**SUBJECT: REQUEST FOR ADDITIONAL INFORMATION REGARDING THE
APPLICATION FOR LICENSE RENEWAL (TAC NO. ME1587)**

REQUEST FOR ADDITIONAL INFORMATION

TRIGA REACTOR FACILITY

LICENSE NO. R-84

Figure 1. Temperature vs. power (hottest channel) fitted to a 5th order polynomial

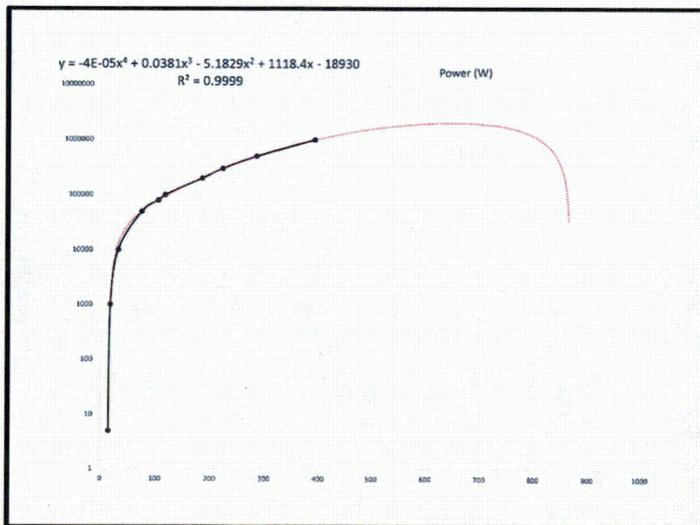
1. NUREG-1537, Part 1, Section 13.1.2, "Insertion of Excess Reactivity," lists insertion-of excess-reactivity events, one of which is the ramp (slow) insertion of reactivity by drive motion of the most reactive control rod or shim rod, or ganged rods. Your RAI response dated April 20, 2012 (ADAMS Accession Nos. ML12122A146 and ML15296A451), as amended on September 21, 2012, (ADAMS Accession No. ML12272A303), stated that "The instantaneous insertion of \$3.00 (2.1 % delta k/k) to the reactor core as a result of a worst case reactivity insertion is bounded by the analysis of the \$3.50 (2.45% delta k/k) pulse limit and would not result in any adverse safety conditions within the AFRRRI TRIGA core."

Your response did not completely address a ramp insertion analyses. Provide a detailed ramp analysis identifying the maximum power level and fuel temperature experienced during the transient. Assume that the first scram, which would terminate the reactivity insertion, would fail in accordance with single failure criteria. Identify which reactor trip terminates the event and its associated response time, including the scram time of the control rods, in order to demonstrate the protection of the safety limit.

There are 2 redundant, independent power and scram channels. If the first scram channel failed, the second channel would terminate the reactivity insertion at the same power level, 1.09 MW(t). For this analysis, the 3 second period RWP is also ignored. There is a delay from the initiation of a scram to the insertion of a control rod of no more than 0.5 seconds. This is the time necessary to close relay contacts, and (in the case of a standard control rod) bleed the magnetic field from the rod drive magnetic coupling, and to bleed the air pressure (in the case of the transient rod drive.) The largest average insertion rate is the transient rod drive, 0.0997 \$/sec. Starting at 1.0 MW(t), the reactor would reach the LSSS of 1.09 MW, a scram would initiate, and the control rod is assumed to continue driving out for .5 seconds, resulting in an additional reactivity insertion of \$0.05, which would produce a positive period of 210 seconds. At t+.5 seconds when the insertion would be terminated and the rods all scrammed, the peak power would be 1,092,598.33 watts. The maximum temperature would be 415.66 degrees C assuming that peak power is reached immediately without delay before scramming the reactor. Similar analysis was performed for the remaining 3 control rods. (See table 2)

Period and temperature were extrapolated from empirical data.

The 2nd column, \$(0.5 sec), is the Average Insertion Rate (\$/sec) from Table 1 multiplied by 0.5 seconds.

The 3rd column, Period(sec), is the period in seconds from the In-Hour curve.

The 4th column, P(0.5 sec), is the power in watts at 0.5 seconds from a 1.09 MW start point.

The 5th column, T(0.5 sec), is the temperature in Celsius corresponding to the in the 4th column.

Figure 4-8 The excess reactivity as a function of burnup for 85-3 Core

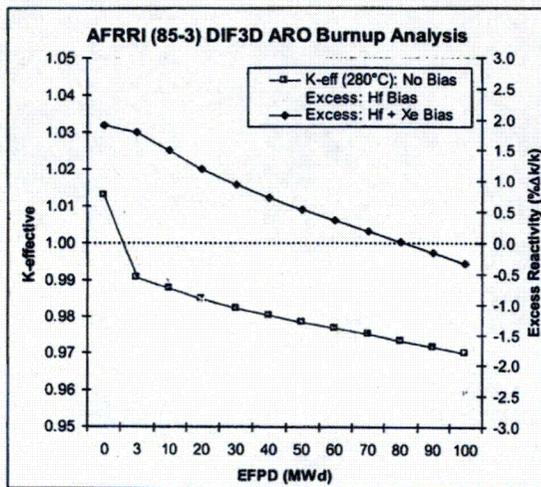
4. NUREG-1537, Part 1, Appendix 14.1, Section 3.1, "Reactor Core Parameters," Item (6)(b), "TRIGA Fuel," provides guidance that the fuel matrix should not exceed 50 percent of its initial concentration. NUREG-1537, Part 1, Appendix 14.1, Section 4.1, "Reactor Core Parameters," Item (6), "Fuel Parameters," provides guidance that the SAR should justify the surveillance method and intervals which ensure that the limit is not exceeded. Provide a TS and surveillance for burnup limit which is consistent with the guidance in NUREG-1537, Part 1, or justify why no change is necessary.

The AFRRRI core contains 87+3 elements. The quantity of uranium 235 contained within a standard 8.5 weight percent TRIGA fuel element is known. From 1964 through 2016, AFRRRI has logged approximately 42 MWD on the current core. Assuming 1gm of fuel is consumed per MWD of operation, 42 grams of uranium 235 has been consumed. Assuming that the burn rate continues into the future, we will reach 50 percent burnup in 2140 years.

In addition, analysis shows that at approximately 80 MWD, excess reactivity will have diminished to the point where we will no longer be able to maintain power and will be forced to either recore or shut down, so that the issue of burnup is self-limiting.

Table 4.8 From chapter 4 of the SAR demonstrates excess reactivity loss as a function of burnup.
